INFORMATION ONLY NOTIFICATION

Change Type Description: Information Only

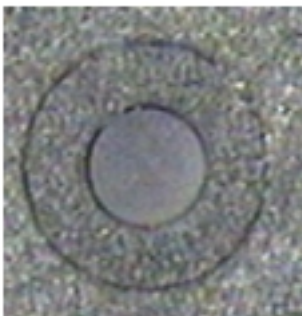
Description of Change (From): Package retract pin hole D=1.3mm

Description of Change (To): BUSH type for retract pin hole D(with bush)=2.0mm,
D(pin)=1.0mm

Reason for Change : Prevent retract pin fast worn out, improve the part life.
